**SUBJECT: NEW VEHICLE DEMONSTRATION / DELIVERY HOLD -
Compliance Recall 18C01**
Certain 2018 Model Year Expedition and Navigator Vehicles
Rear Door Modules

CERTAIN 2018 MODEL YEAR EXPEDITION AND NAVIGATOR VEHICLES — REAR DOOR MODULES

FIGURE 1

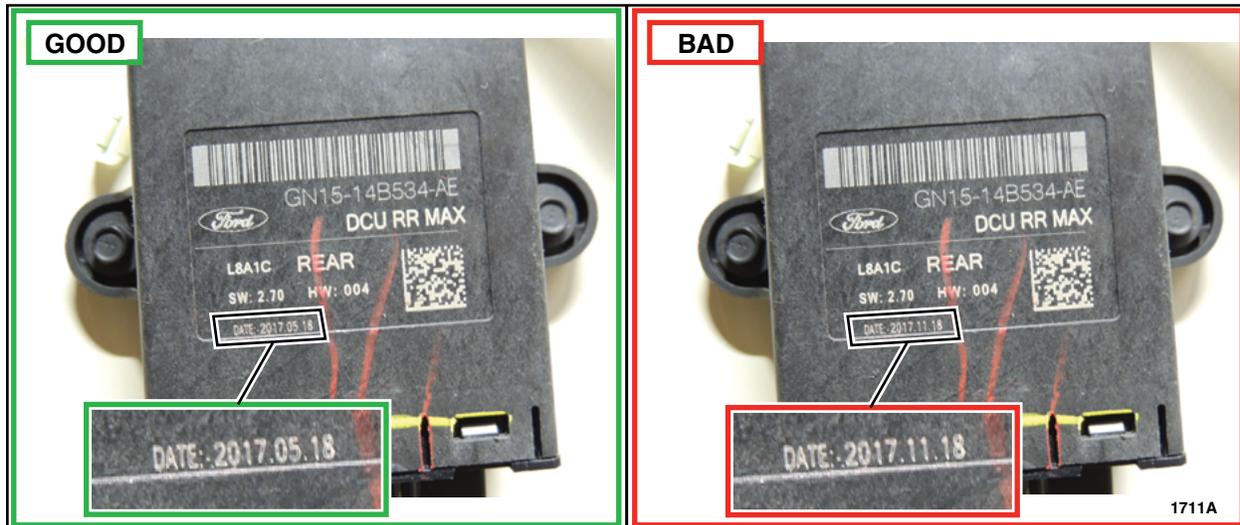
2. Inspect the RH and LH rear door module build date. See Figure 1. Is the build date between 2017.11.10 and 2017.11.20?

Yes – Replace the affected rear door module(s). Please follow the WSM procedures in Section 419-10.

No – No action required. Reinstall the RH and LH rear door trim panels. Please follow the WSM procedures in Section 501-05.
